Assessment Report

Case reference	SMC-EDB-006			
A 11 (1 1 (1)	T.,			
Application details	New pedestrian/cycle bridge over the Union Canal linking Edinburgh International Climbing			
	Arena to the new Wavegarden development and the Craigpark housing development			
Site address	Union Canal, Fountainbridge to River Almond section, Edinburgh (SM 11097)			
Applicant	City of Edinburgh Council			
Determining Authority	Historic Environment Scotland (HES)			
Local Authority Area	City of Edinburgh Council			
Reason(s) for notification	Notification Direction 2015 – works to be granted Scheduled Monument Consent by Historic Environment Scotland go beyond the minimum level of intervention that is consistent with conserving what is culturally significant in a monument			
	1			
Representations	Nil			
Date notified to Ministers	2 September 2020			
Date of recommendation	24 September 2020			
Decision / recommendation	Clear

Description of Proposal and Site:

Figure 3 – before and after viewpoints from upper embankment

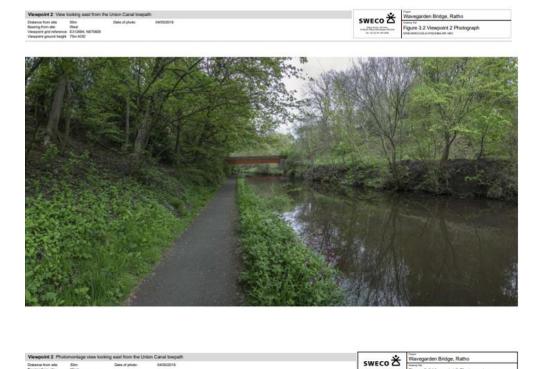
- 3. The proposed works involve the construction of a pedestrian and cycle bridge over the Union Canal. The majority of works relating to the construction of the bridge, including the north and south abutments and their foundations would be outwith the scheduled area, affecting the slopes of the cutting above the canal. The proposed bridge would be constructed using weathering steel girders supporting a recycled plastic deck and parapet moulded and coloured to a timber-effect finish. The wingwalls of the abutments would be clad in stone. Vegetation clearance works would be required to construct the bridge and its abutments, and the bridge structure would be highly visible to both users of the canal towpath and to users on the canal itself. (See Figures 3 and 4).
